# The Meridian Community Building Rebuild

### SHOP DRAWING REVIEW

The Meridian Community Building Rebuild  
3 Meridian Place, Ottawa  
Job No. 19-356

Submittal Date: July 23, 2019

104.1

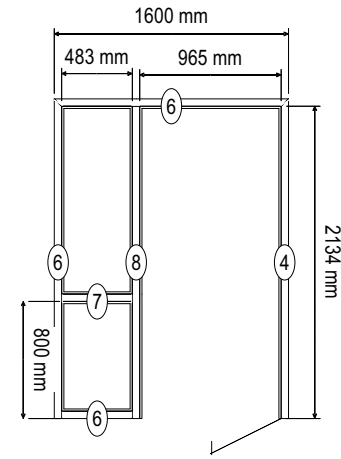
**SITE CONFIRM**

4

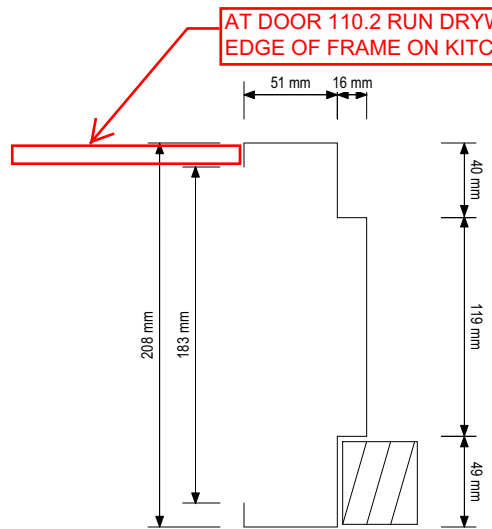
AT DOOR 110.2 RUN DRYWALL INTO  
EDGE OF FRAME ON KITCHEN SIDE

H

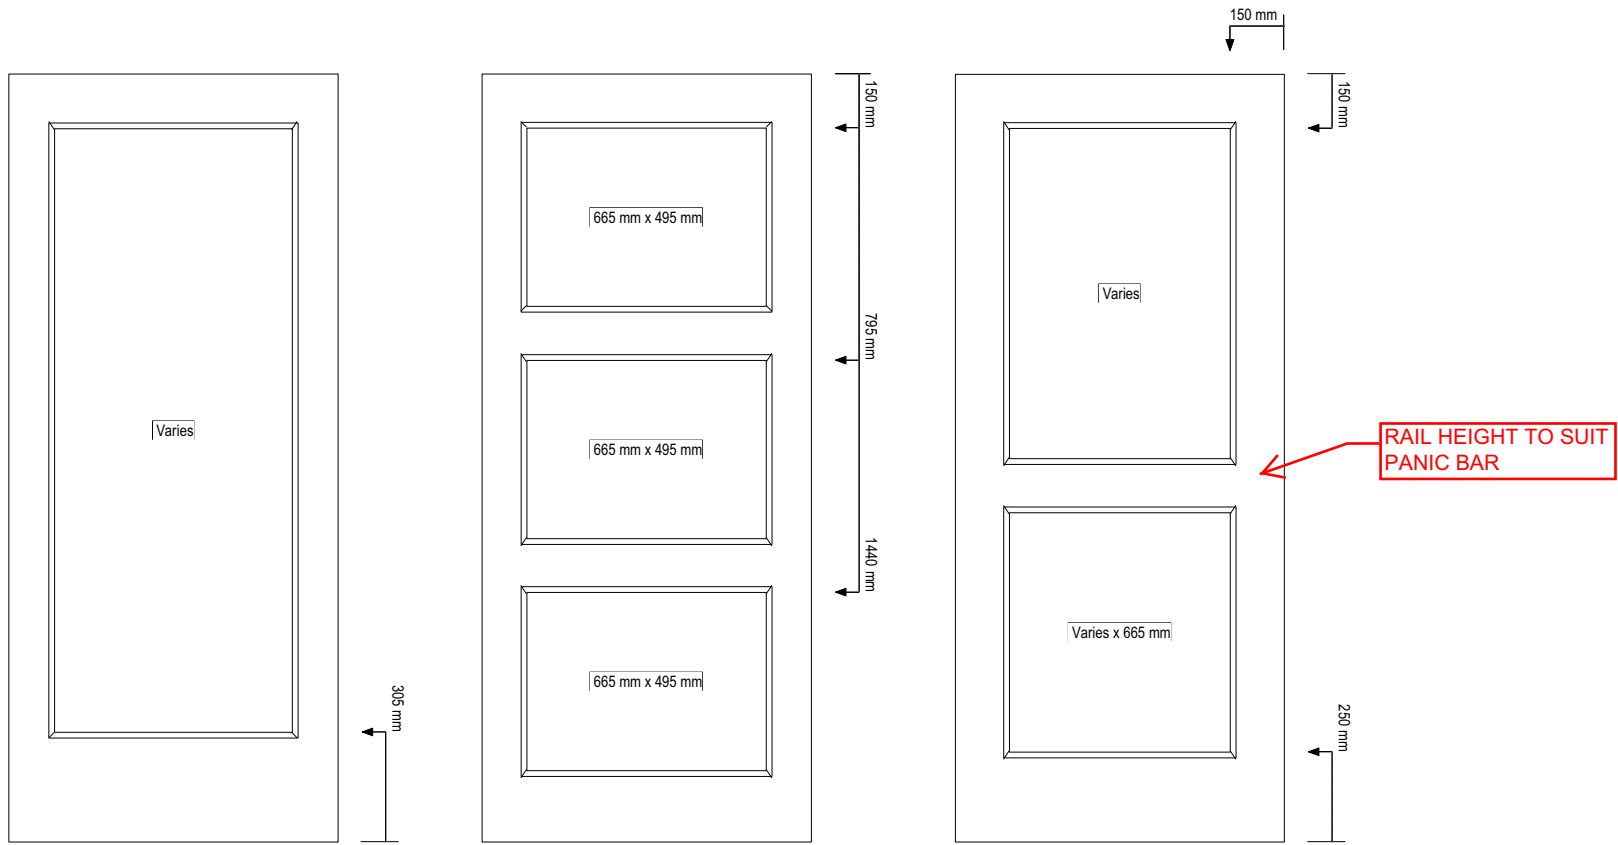
RAIL HEIGHT TO SUIT PANIC BAR

Existing Wall Anchor (EWA)

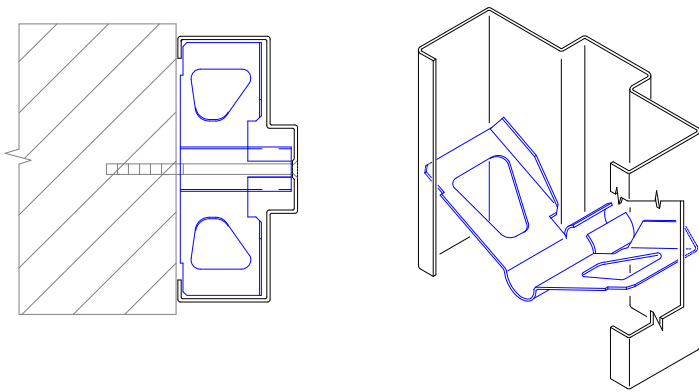
IS THIS CORRECT ANCHOR FOR  
FRAME TO WRAP AROUND WOOD  
STUD WALL?
